Item Name: Basket Hoop

| DESIGN # | DRAWN BY CP | DART AEROSPACE LTD HAWKESBURY, ONTARIO, CANADA | |
| DATE 02.07.10 | | TITLE BASKET HOOP | SCALE NTS |

| DRAWING NO. D3166 | TITLE BASKET HOOP | REV.A1 | DART AEROSPACE LTD ENGINEERING ORDER | | D.E.O. NO. D3166-A-2 | SHEET NO. 1 OF 1 | SCALE NTS |

D3166-1 BASKET HOOP

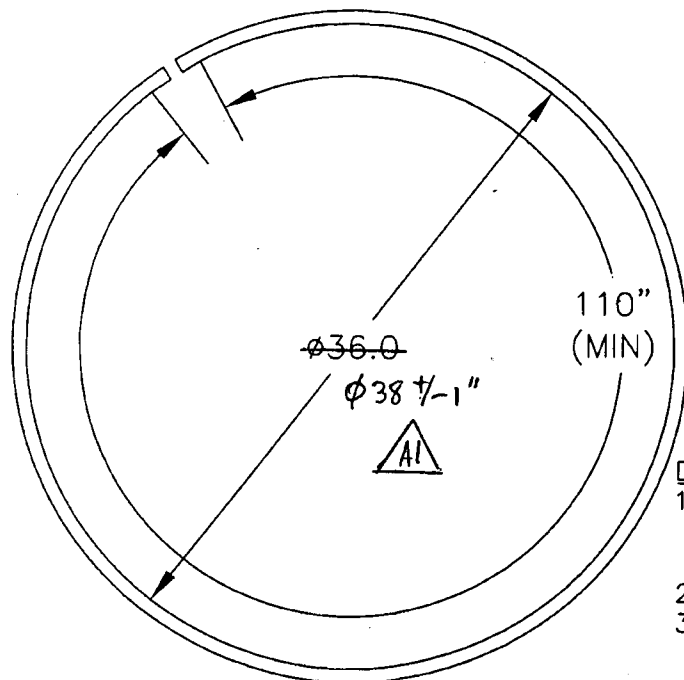
| A1 | 04.04.08 | 38+/-1 WAS 36.0 | |

1) MODIFY MATERIAL NOTE FOR D3166-1 AS SHOWN:

WAS:

1) MATERIAL: AISI 304/316 SS SQUARE TUBING,
0.75" x 0.75" x 0.063 WALL, 60.00" LONG
(REF DART SPEC. M304TS0.750W.063)

2) MODIFY MATERIAL NOTE FOR D3166-3 AS SHOWN:

WAS:

1) MATERIAL: AISI 304/316 SS SQUARE TUBING,
0.75" x 0.75" x 0.063 WALL, 120.00" LONG
(REF DART SPEC. M304TS0.750W.063)

IS:

1) MATERIAL: AISI 304/316 SS, 3/4 X 3/4 X 0.065 WALL SQUARE TUBING,
60.00" LONG
REF. DART SPEC M304TS0.750W.065

IS:

1) MATERIAL: AISI 304/316 SS, 3/4 X 3/4 X 0.065 WALL SQUARE TUBING,
120.00" LONG
REF. DART SPEC M304TS0.750W.065
